TURKEY POINT NUCLEAR GENERATING UNIT NO. 3

ATTACHMENT TO LICENSE AMENDMENT NO. 33
TO THE TECHNICAL SPECIFICATIONS
FACILITY OPERATING LICENSE NO. DPR-31
DOCKET NO. 50-250

SAFETY EVALUATION BY THE OFFICE OF NUCLEAR REACTOR REGULATION
SUPPORTING AMENDMENTS NOS. 33 AND 27 TO LICENSE NOS. DPR-31 AND DPR-41
FLORIDA POWER AND LIGHT COMPANY
TURKEY POINT NUCLEAR GENERATING UNITS NOS. 3 AND 4
DOCKETS NOS. 50-250 AND 50-251

Figure 2.1-1a Reactor Core Thermal and Hydraulic Safety Limits, Three Loop Operation

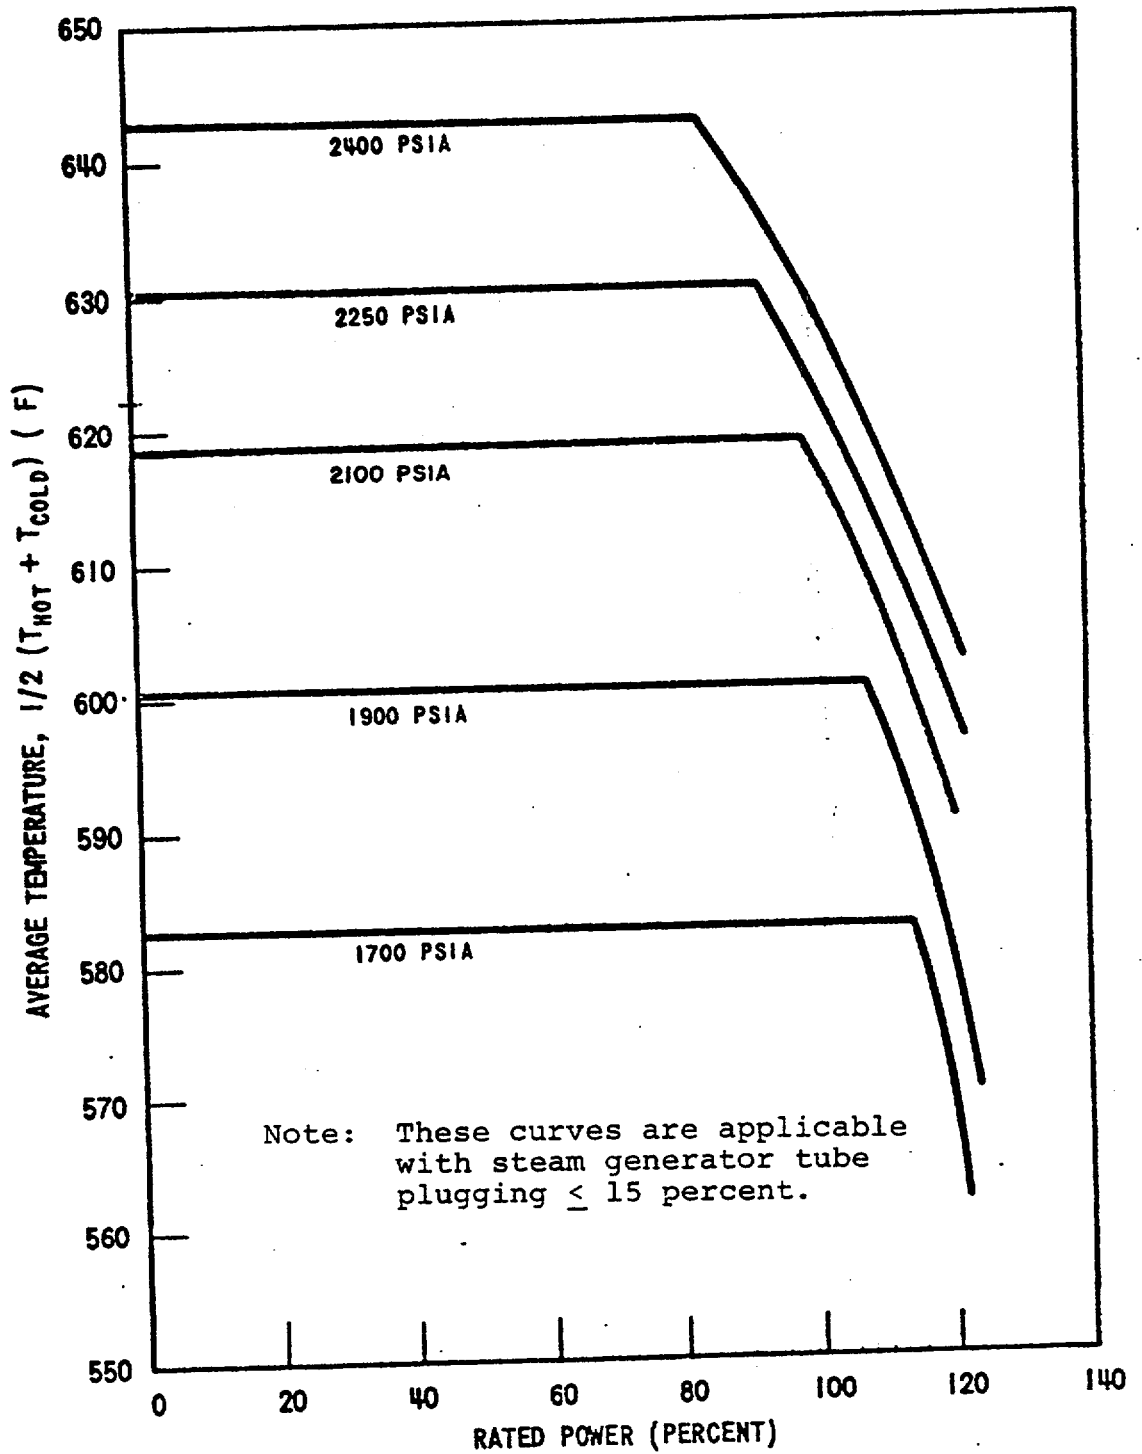
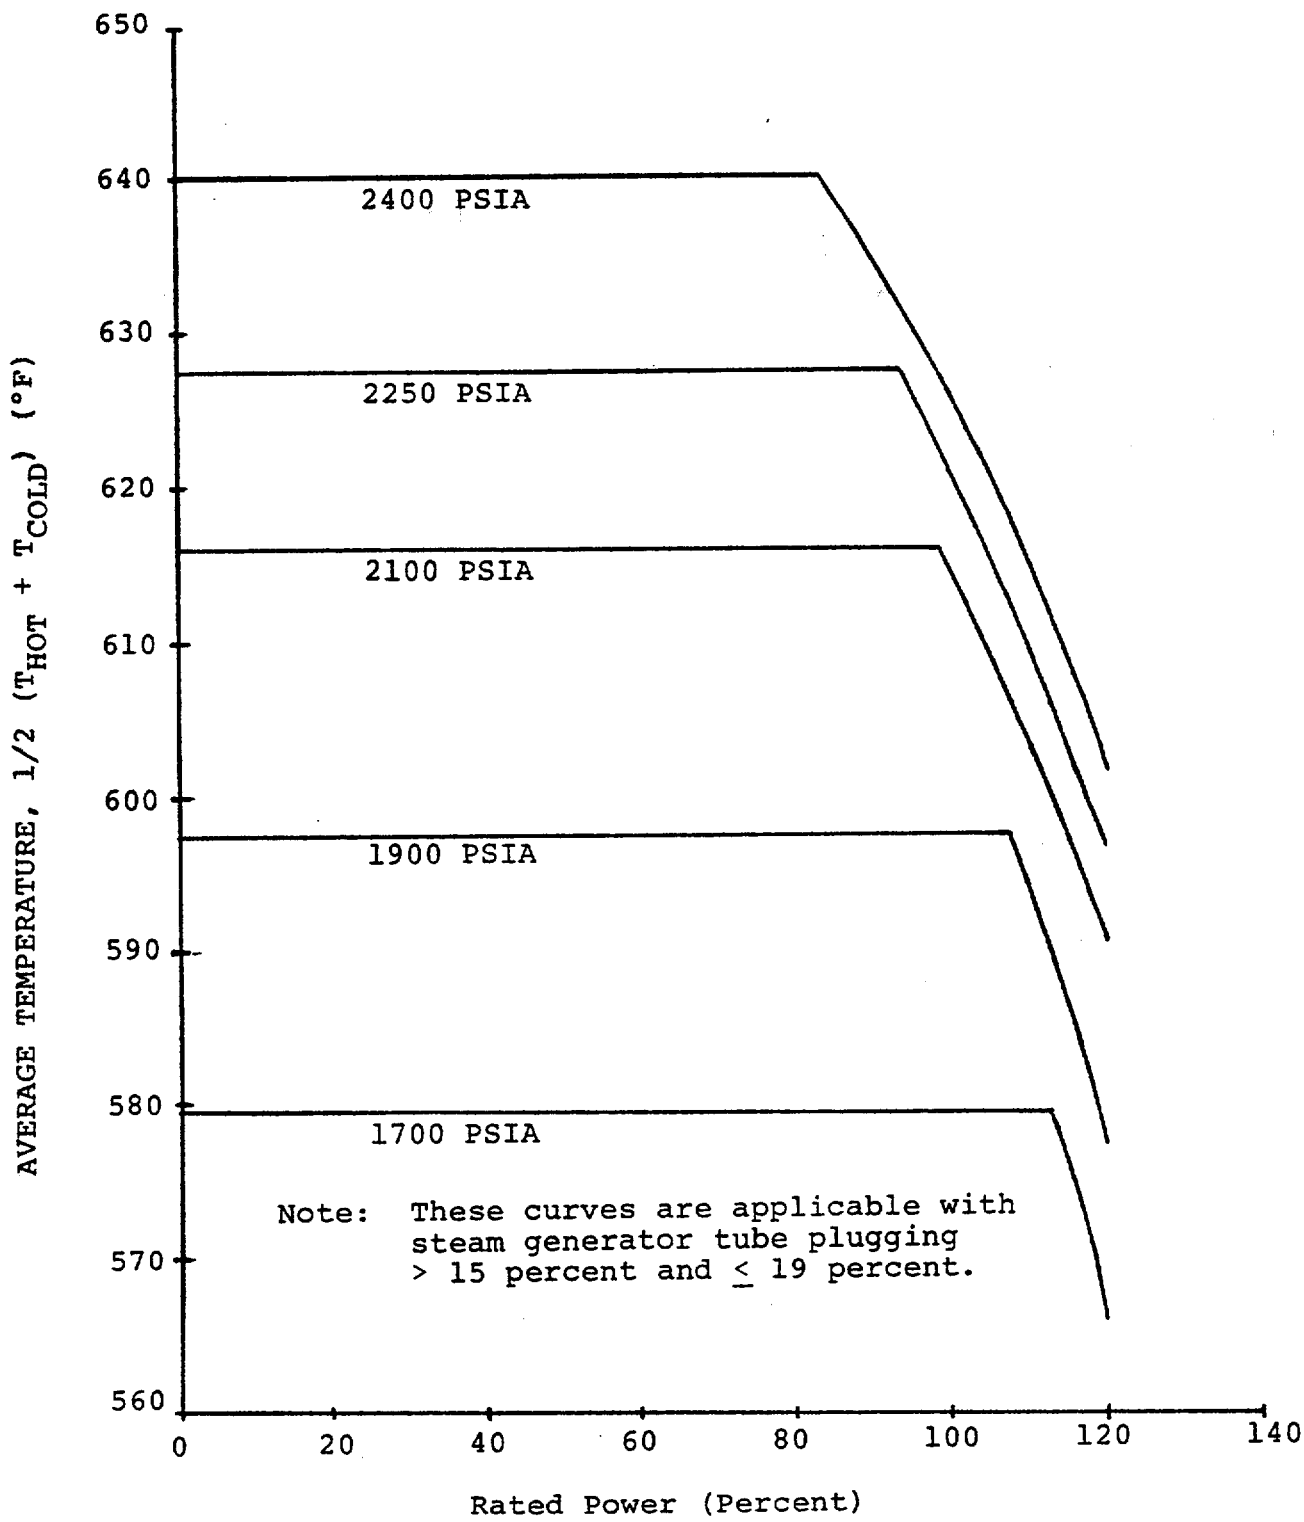
Figure 2.1-1
-
2.3-2
2.3-3
3.1-7
3.2-3

Figure 2.1-1
Figure 2.1-1a (new)
2.3-2
2.3-3
3.1-7
3.2-3

Figure 2.1-1a Reactor Core Thermal and Hydraulic Safety Limits, Three Loop Operation

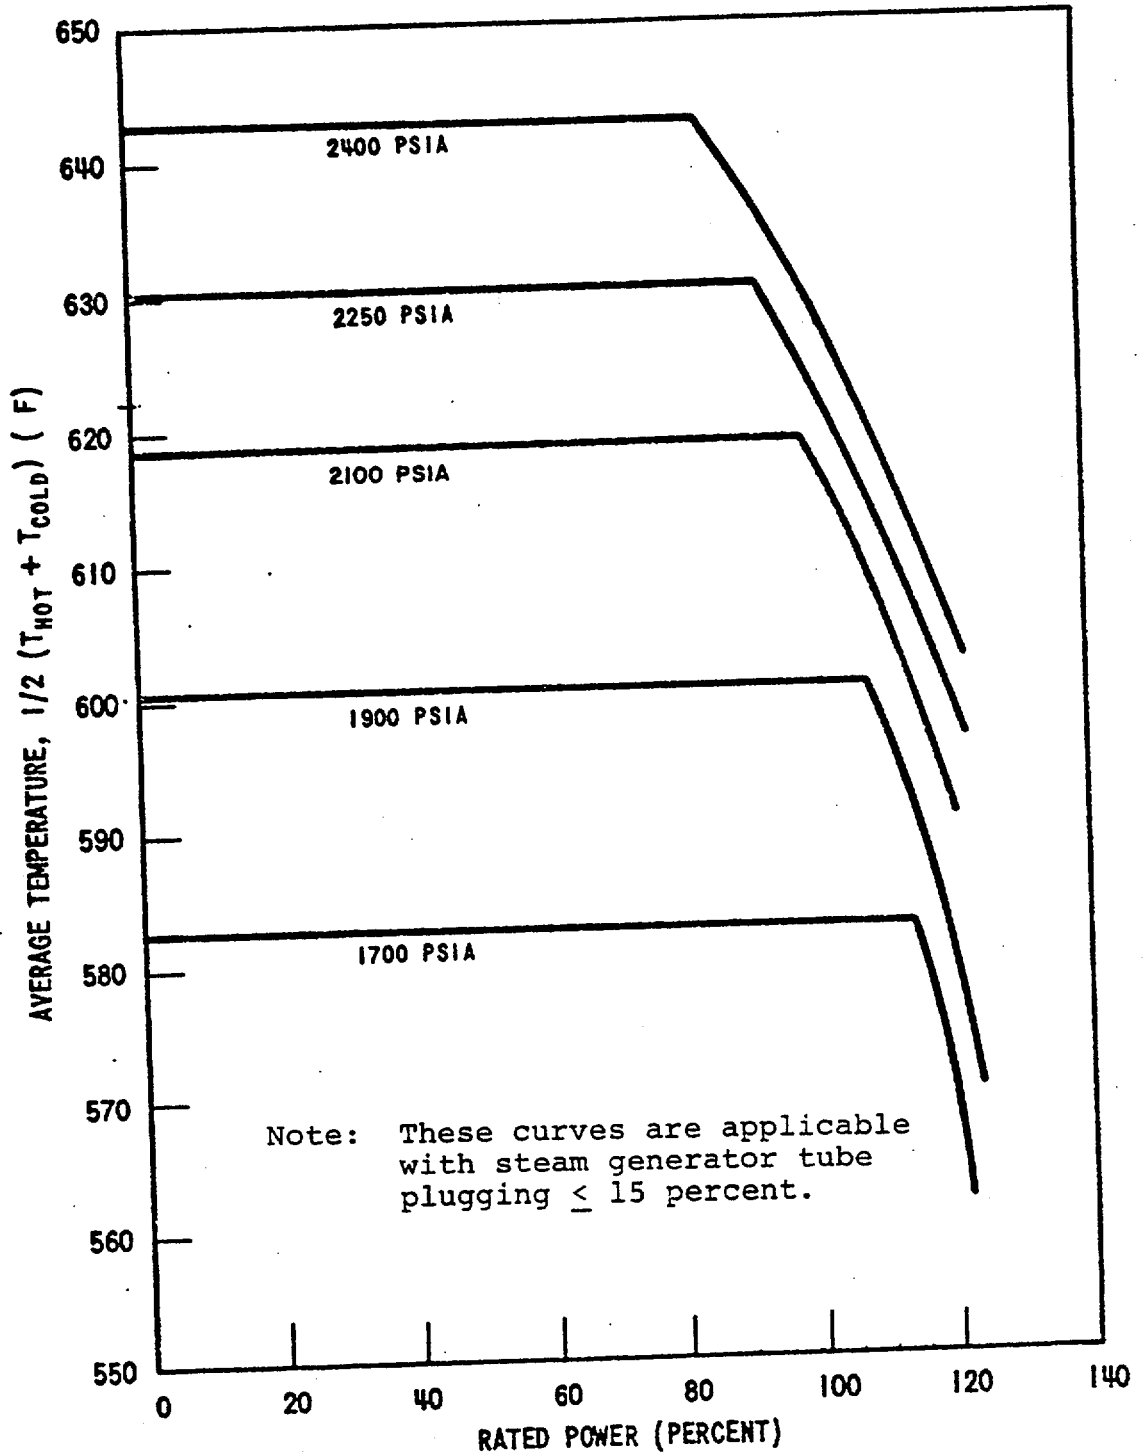
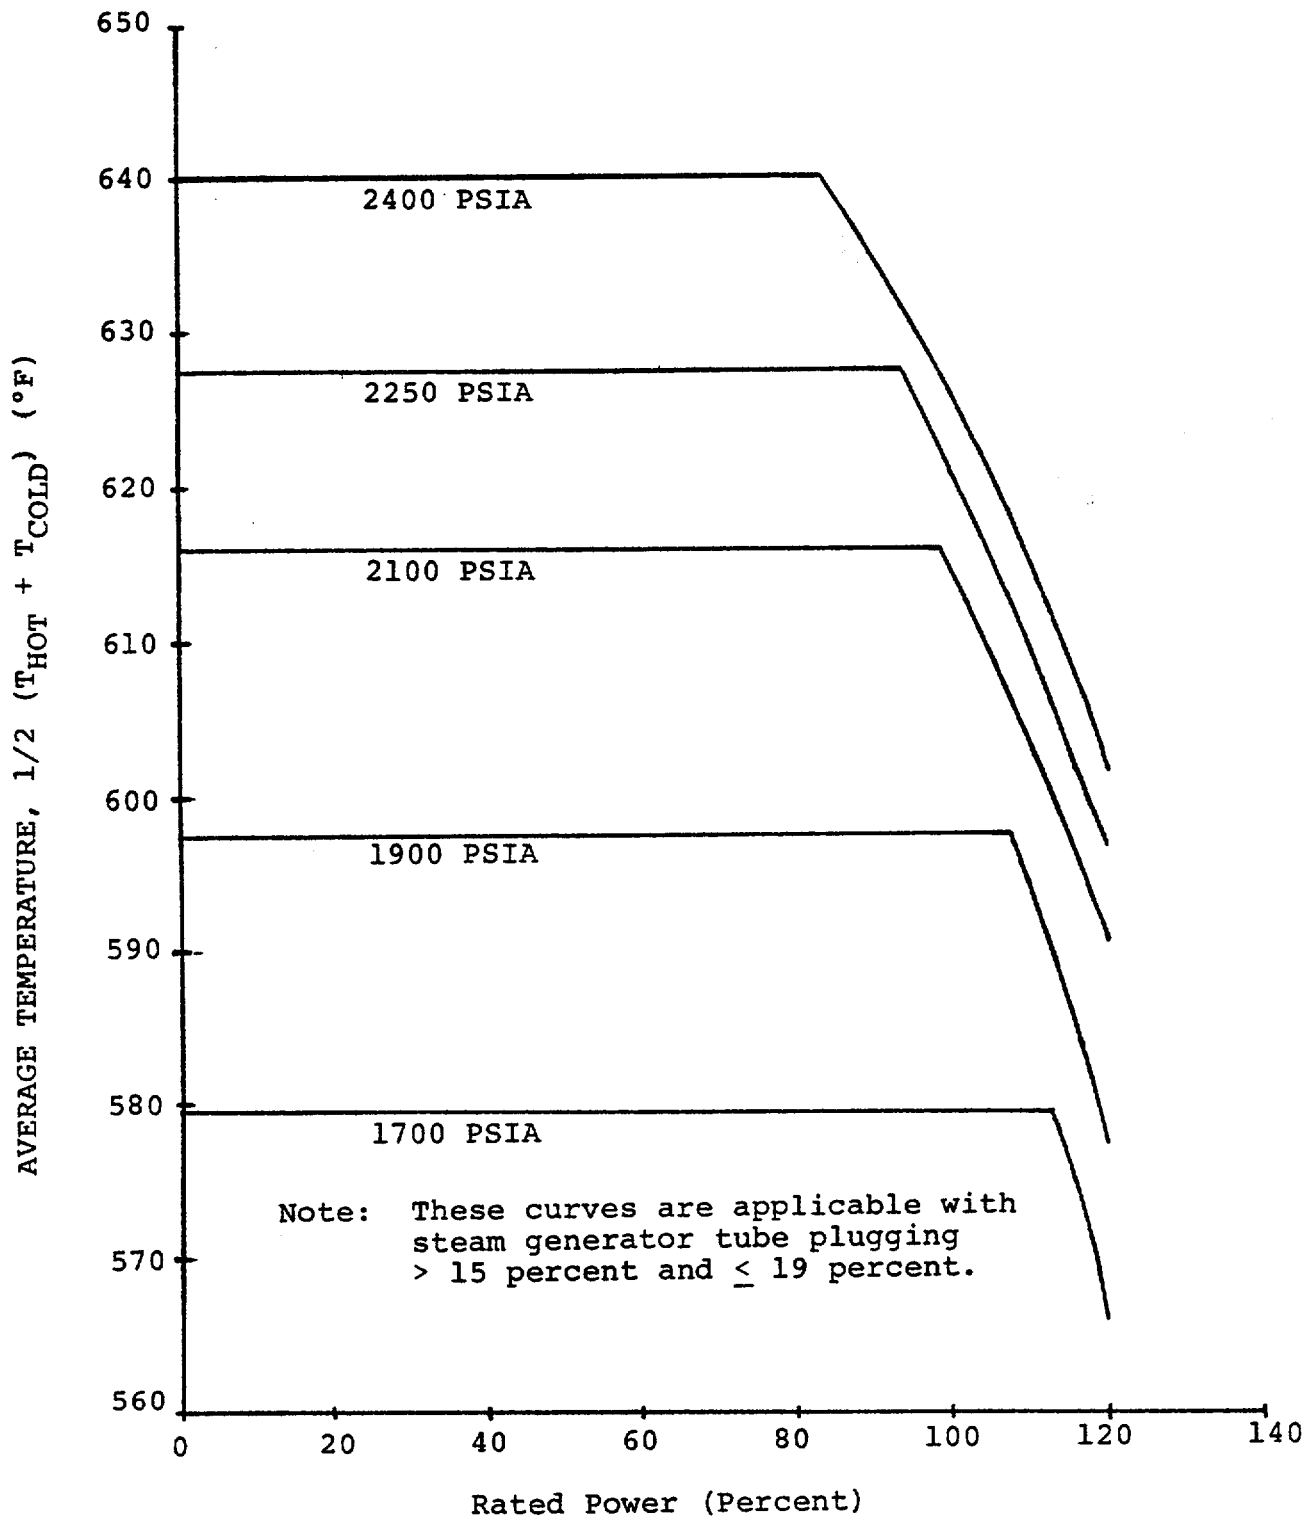
Figure 2.1-1

Figure 2.1-1

Figure 2.1-1a (new)
